RE: **Addendum No. 1/City of Mission Event Center**
Request for Proposal No.: 17-010-11-29

ADDENDUM 1

Date: 11-16-2016
Project: Mission Event Center
Project No.: 2016-01

SHEET TITLE
OVERALL SITE PLAN W/ ALTERNATES

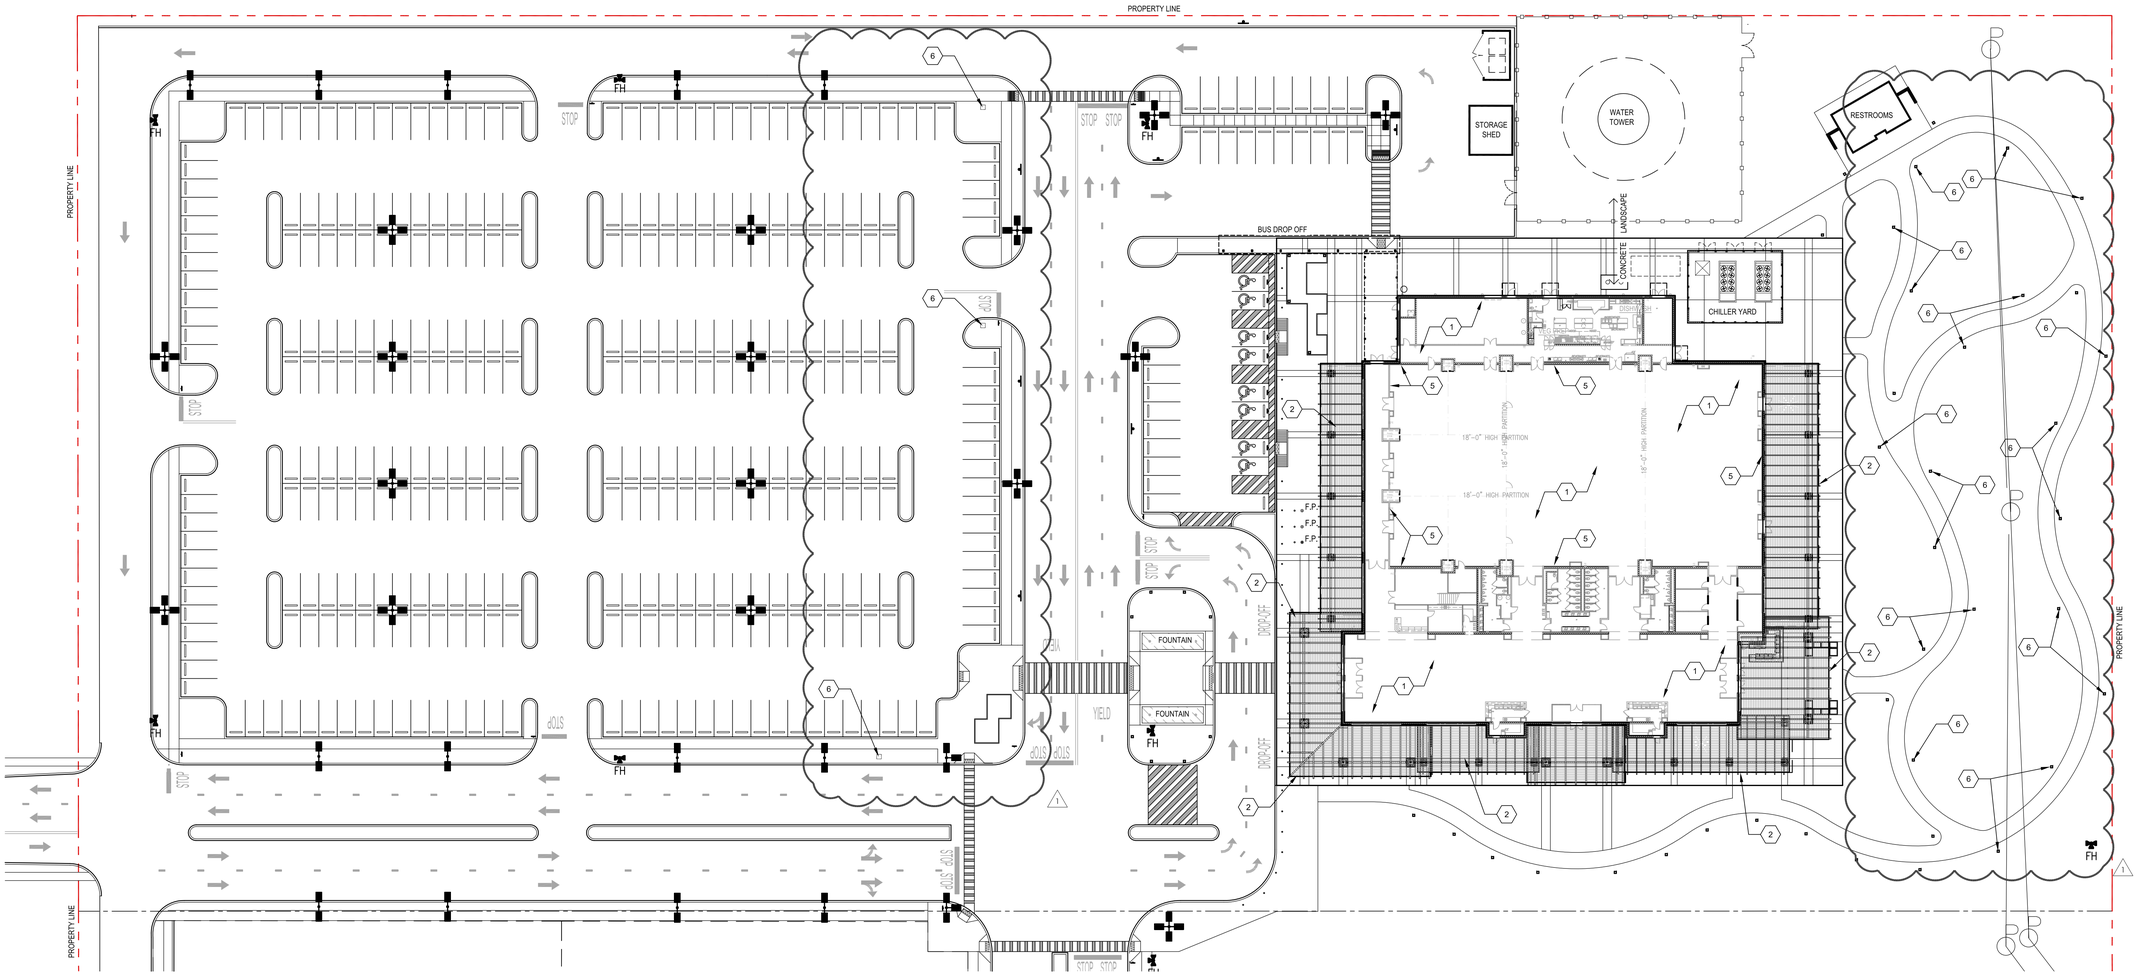
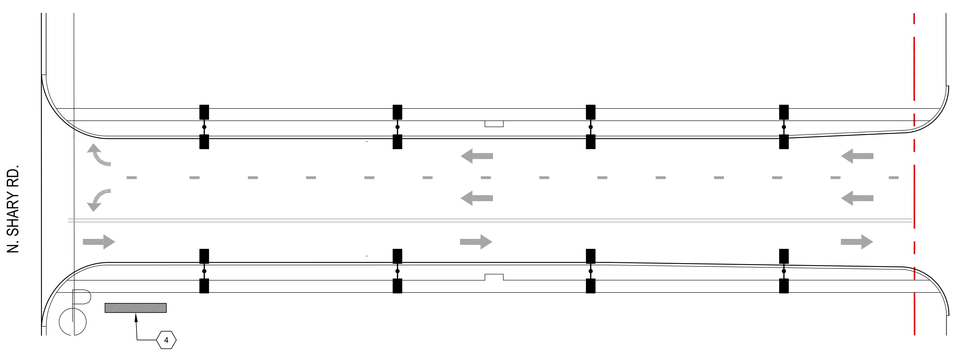
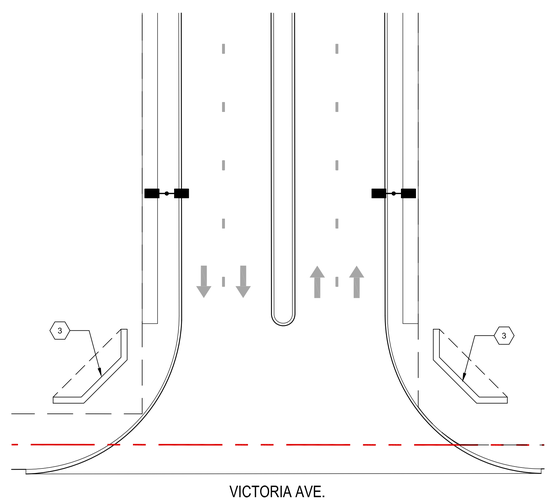
a. *Refer to Revised **Sheet ALT0.02** attached for addition of Alternate #6*
    b. *Refer to Revised **Bid Form** attached for addition of Alternate #6*
    c. *Refer to Revised Schedule of Alternates **Section 01 23 00** attached herewith.*

SHEET NO.
ADD#1/S1
1 of 5

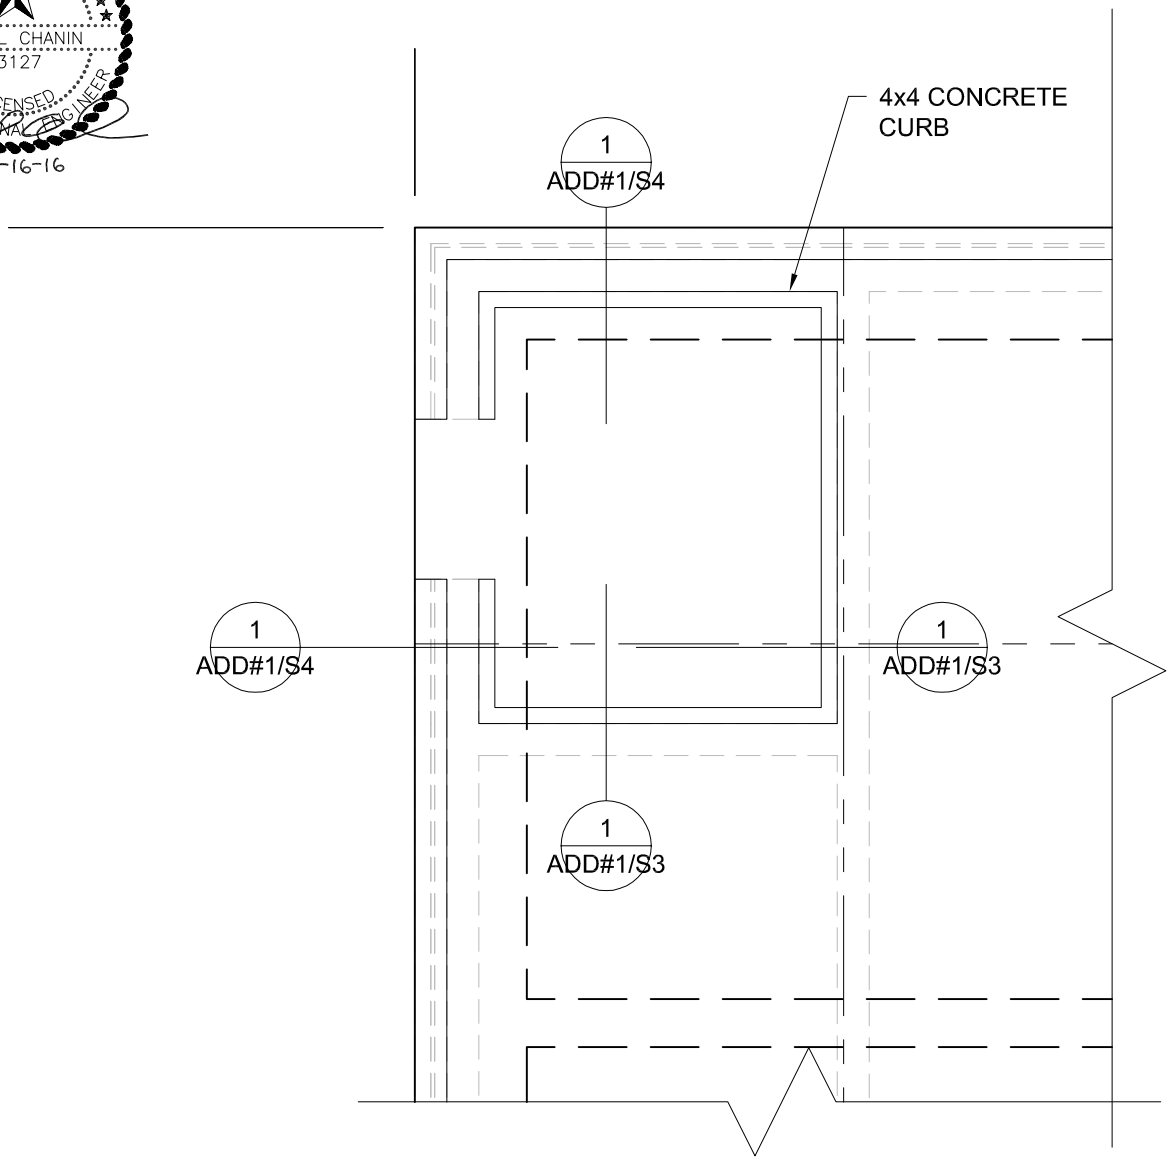
1. *Modification:* Add 4" x 4" concrete curb in all the walls in the Riser Room except at door location. See revised **Sheet ADD#1/S1, ADD#1/S3 & ADD#1/S4** attached herewith.

SHEET NO.
ADD#1/S2
2 of 5

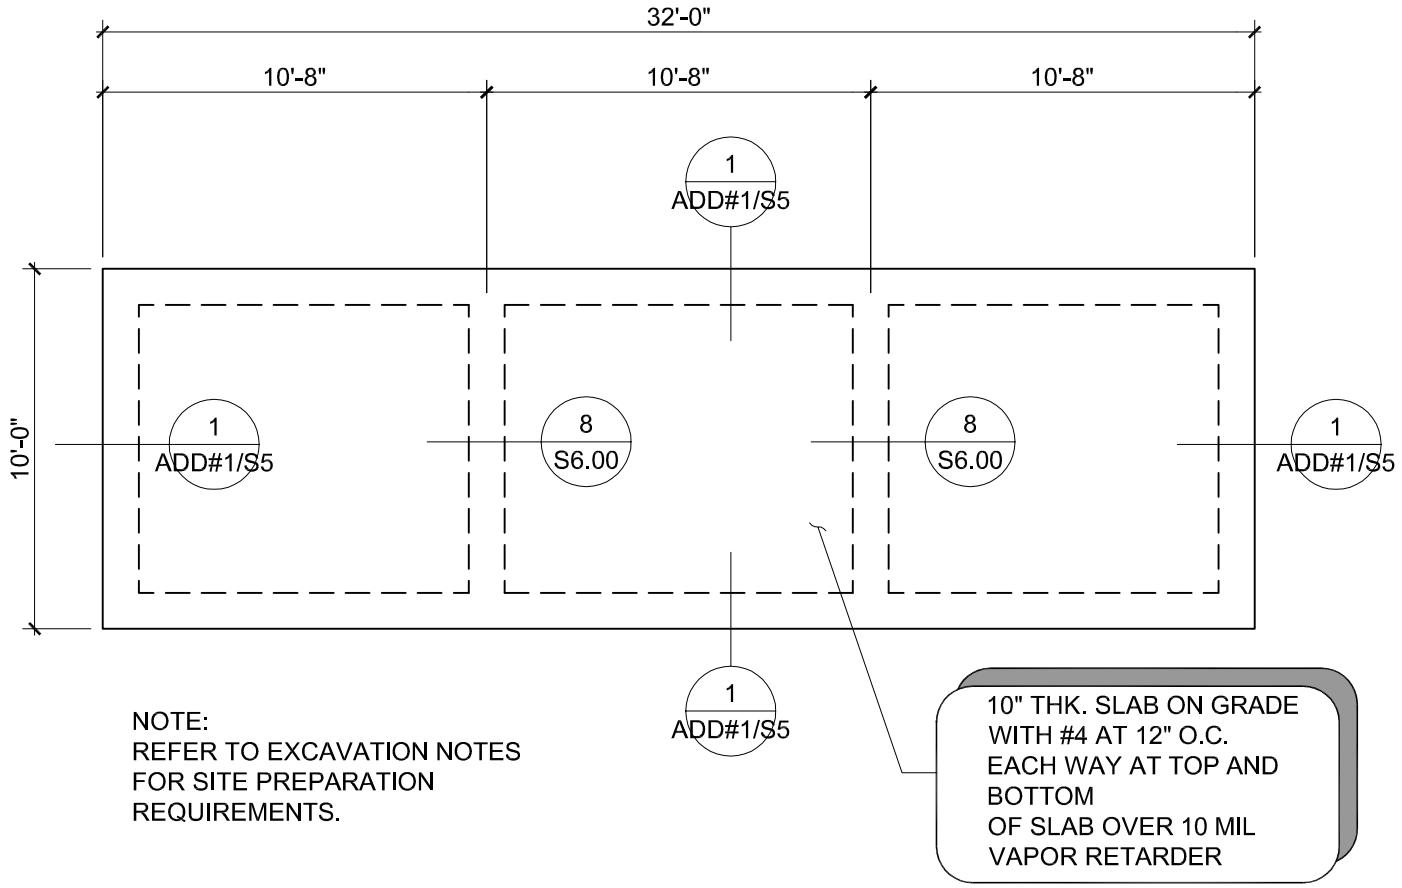
2. *Clarification:* Foundation design for fountain is on Sheet **ADD #1/S2 & ADD#1/S5** attached herewith.

SHEET NO
E1.0

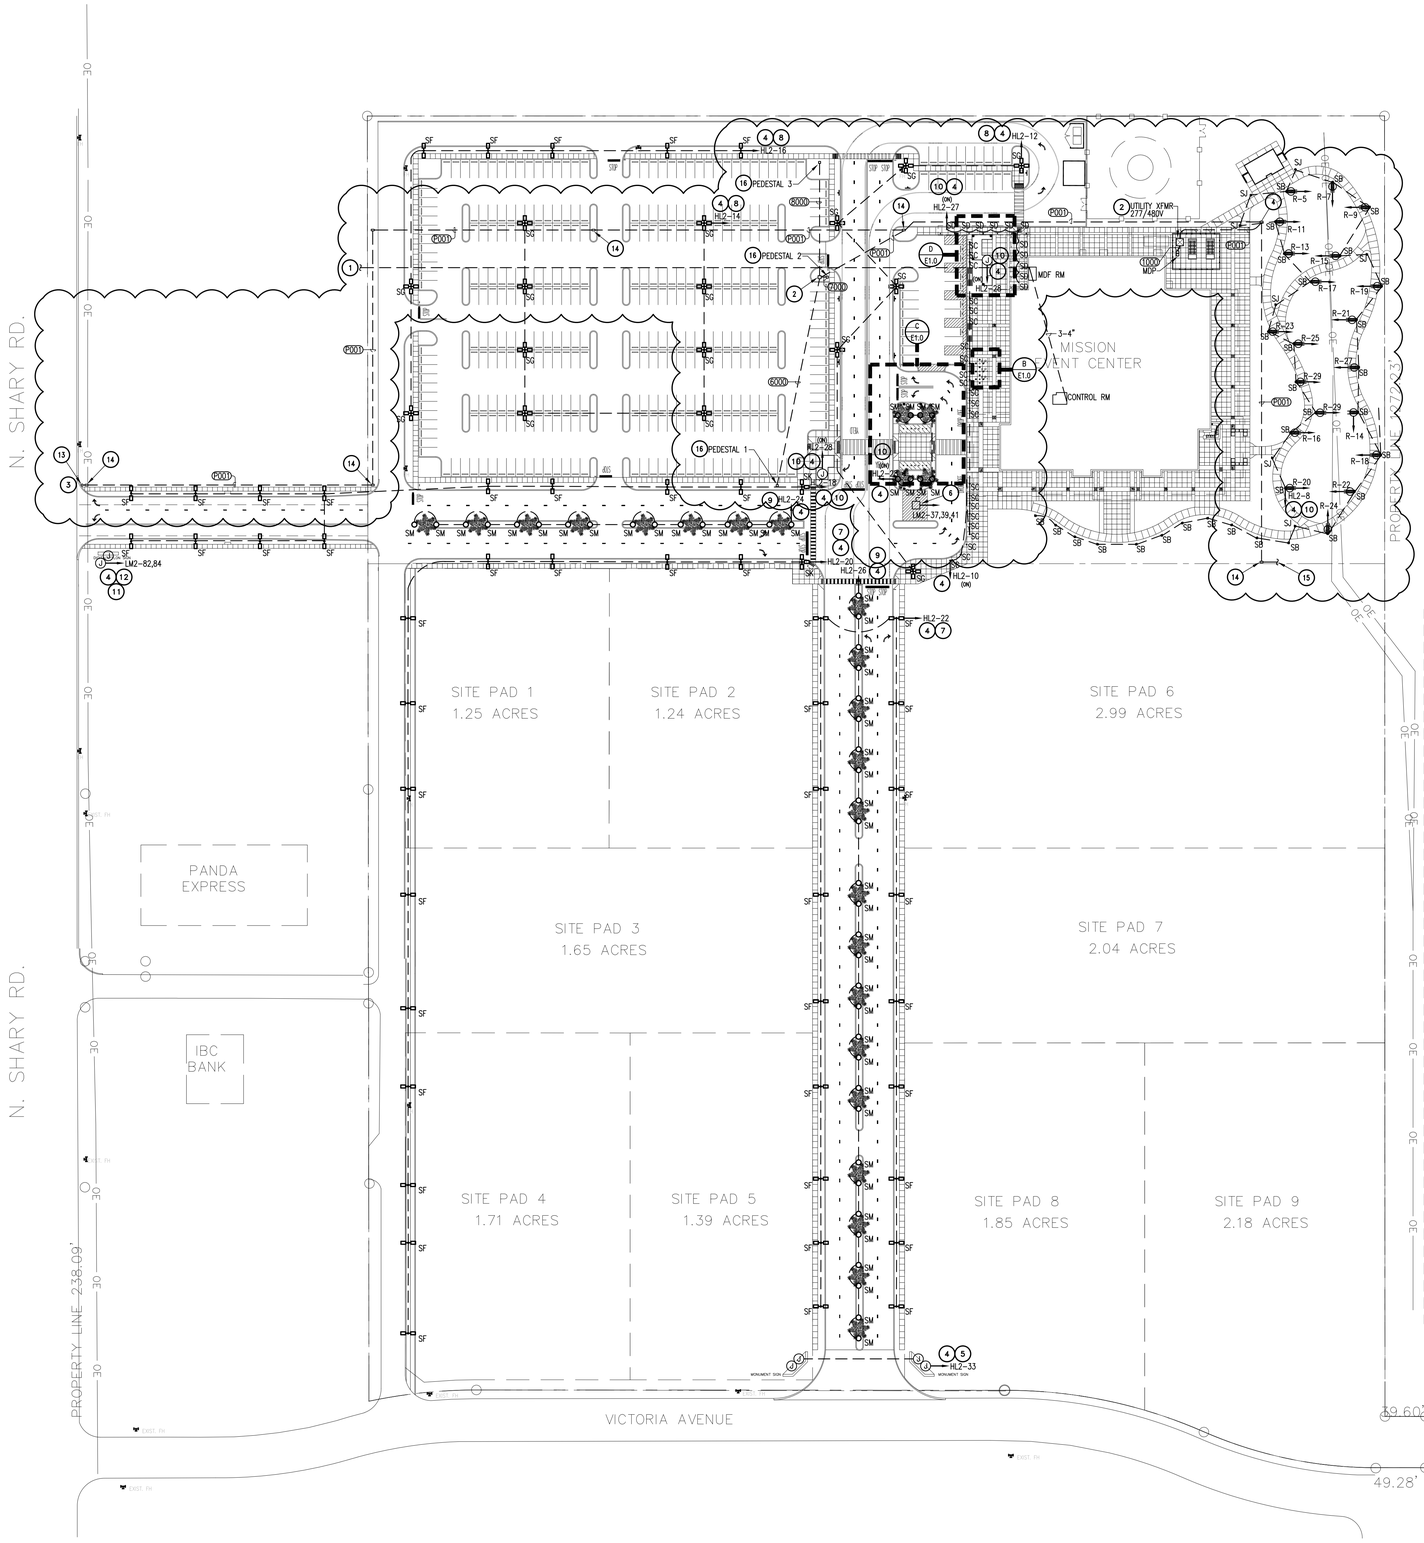
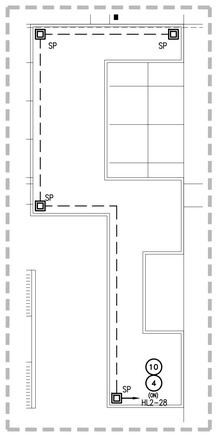
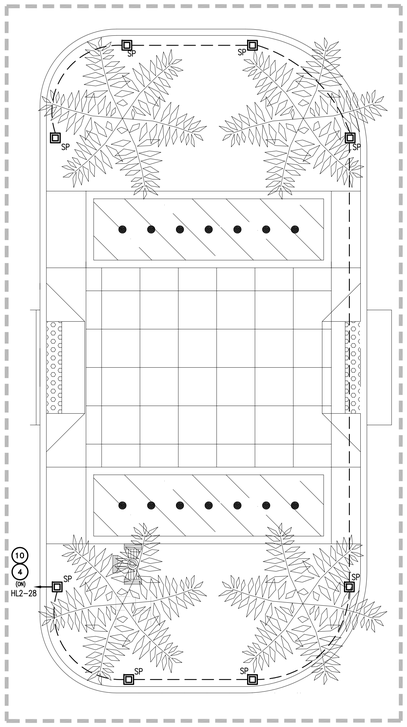
1. ***Alternate #6:*** Additional electrical access in the parking lot and in the green area to the East of the building will be provided. Refer to Revised **Sheet E1.0** attached herewith.

Item 2 Sheet E1.0, Electrical Site Plan, Revised utility company site plan and included allowance for MVEC. Added three electrical service pedestals at parking lot. Added receptacles at bollard locations at trail. Refer to attached drawing.

SHEET NO
E1.1

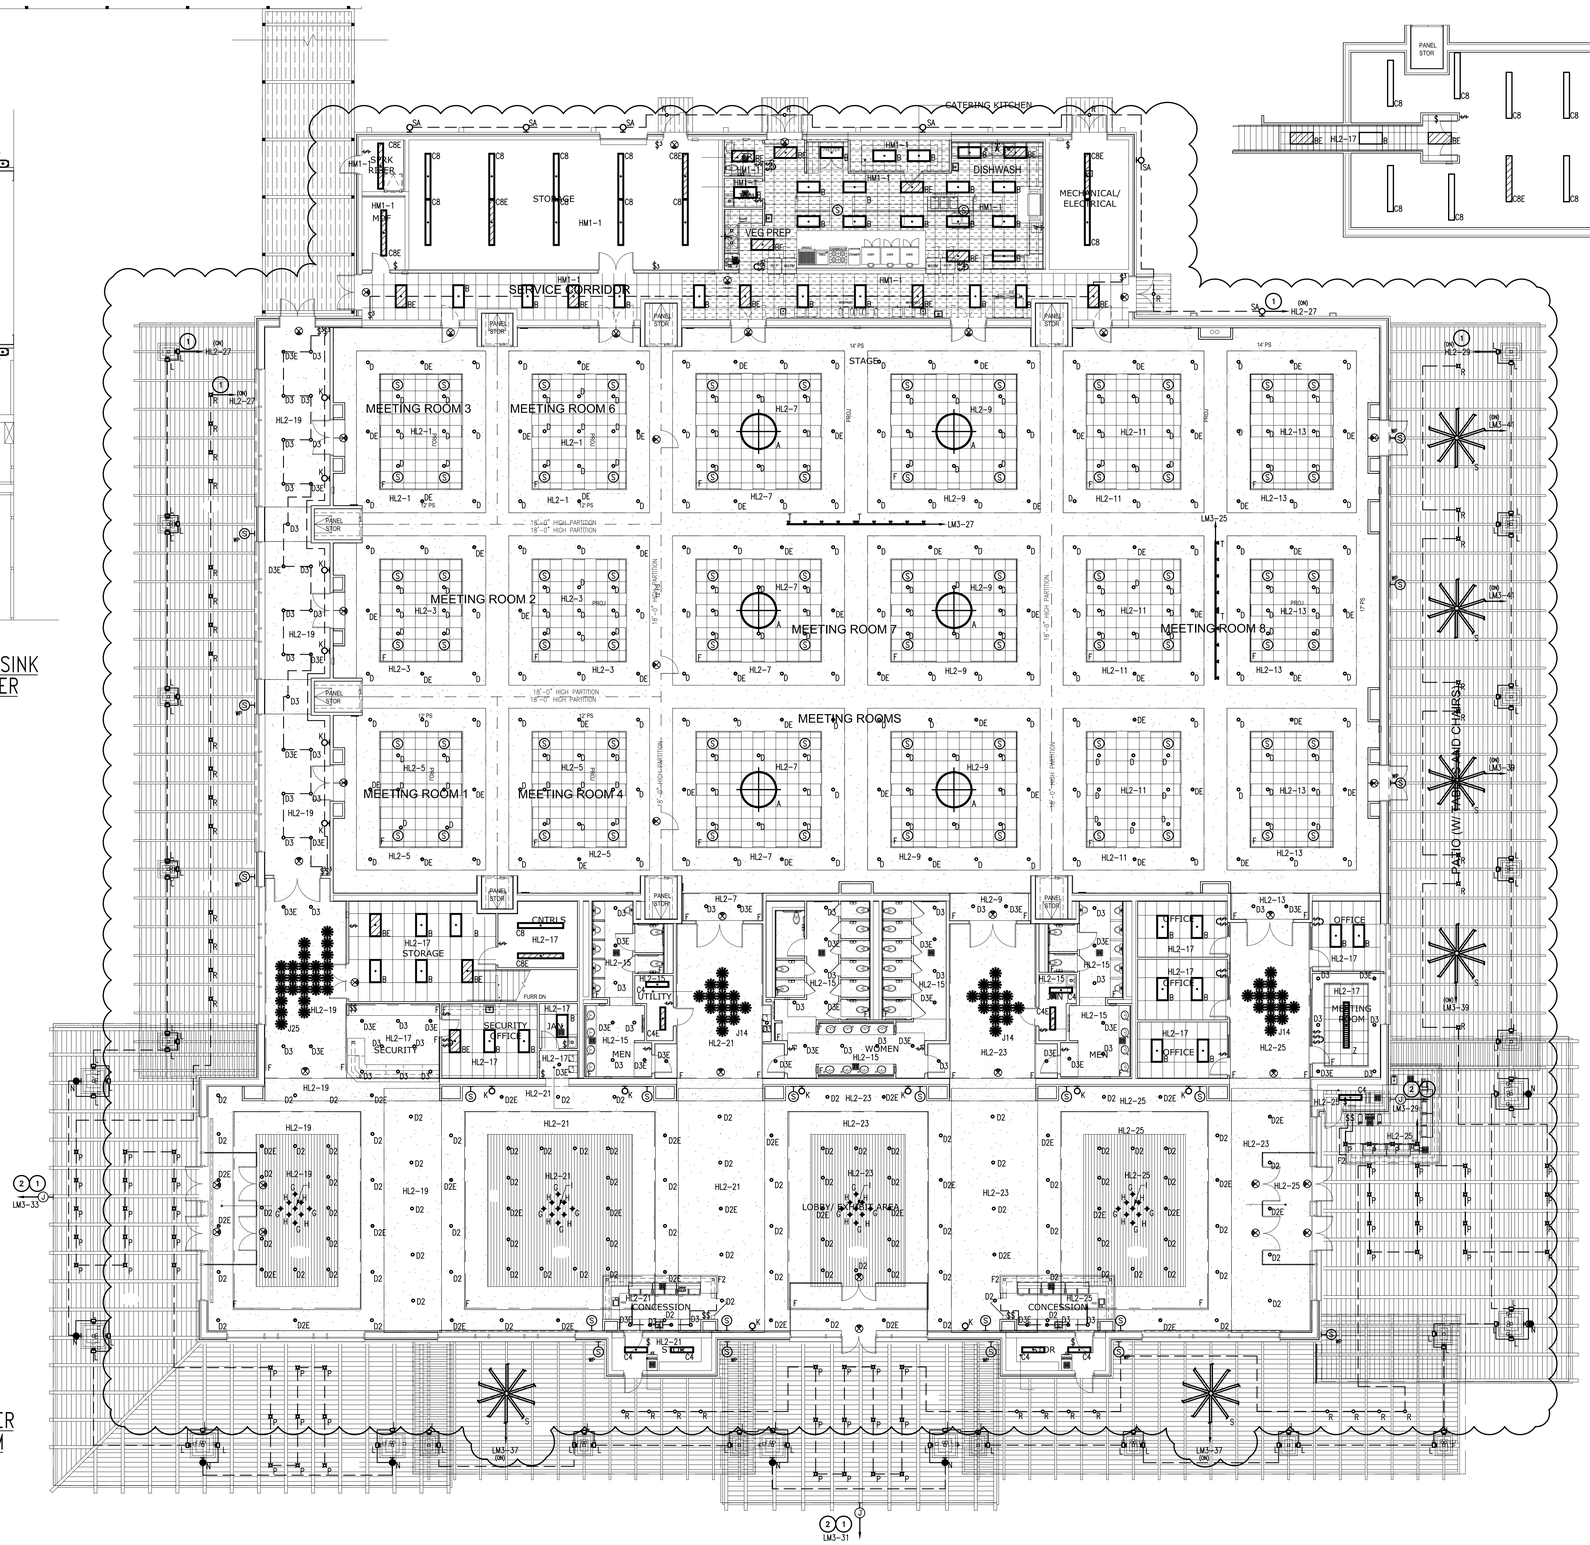
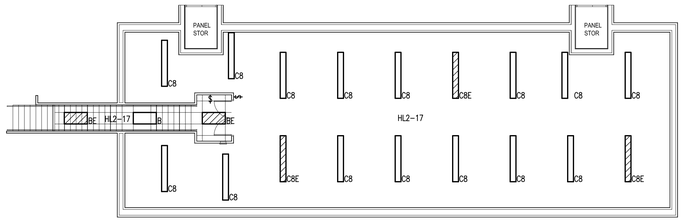
Item 3 Sheet E1.1, Electrical Lighting Plan, revised circuits for fans, added speakers, and added general note. Refer to attached drawing.
